Access Compliance Report

Public Rights-of-Way

Intersection ID: 18227	Main Street: DREXMORE_AV	Cross Street: E WOODLAWN RD	Location: SE
ADA ID: F463723FAA77	Ramp Type: PerpDiag	Initial Pass/Fail: Fail	Overall Compliance: No
		Severity Score: 25

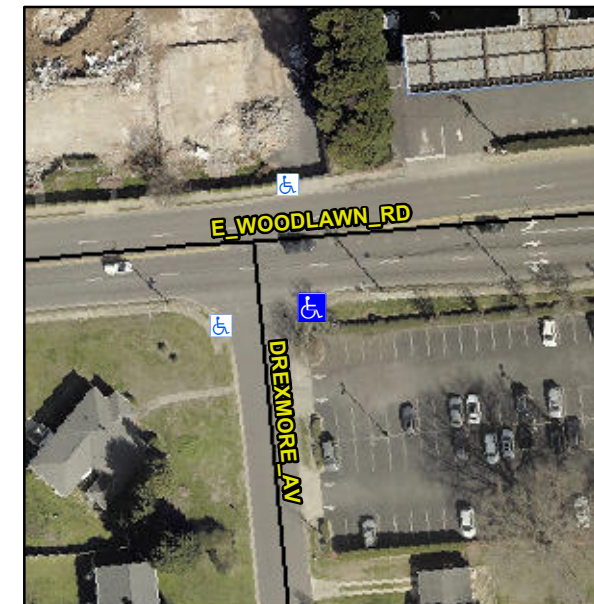
Not Found, R304.2.2, R304.5.3

Compliance	Description	Data	Compliance	Description	Data
N/A	Ramp Length (in)	74.0	No	Ramp Slope (%)	10.1
Yes	Ramp Width (in)	48.0	No	Ramp XSlope (%)	5.1
N/A	Flare Type LT	N/A	N/A	Flare Type RT	N/A
N/A	Flare Slope LT (%)	N/A	N/A	Flare Slope RT (%)	N/A
N/A	Flare Traversable LT?	N/A	N/A	Flare Traversable RT?	N/A
N/A	Landing Length (in)	N/A	N/A	DWS Provided?	N/A
N/A	Landing Width (in)	N/A	N/A	DWS Contrast?	N/A
N/A	Landing Slope (%)	N/A	N/A	DWS Length (in)	N/A
N/A	Landing X Slope (%)	N/A	N/A	DWS Full Width?	N/A
N/A	Landing Curb? (Y/N)	N/A	N/A	DWS Offset (in)	N/A
N/A	Shared Landing?	N/A			
N/A	Gutter Ponding?	N/A	N/A	Gutter Slope (%)	N/A
N/A	Gutter Lip Ht (in)	N/A	N/A	Gutter X Slope (%)	N/A
N/A	Painted X Walk1?	No	N/A	Painted X Walk2?	No
	X Walk 1 Direction	To N		X Walk 2 Direction	To W
N/A	X Walk 1 Width (in)	N/A	N/A	X Walk 2 Width (in)	N/A
	X Walk 1 Slope (%)	5.6		X Walk 2 Slope (%)	0.2
	X Walk 1 X Slope (%)	1.1		X Walk 2 X Slope (%)	4.0

Remove & Replace Curb Ramp With Two New Directional Ramps or Equivalent.
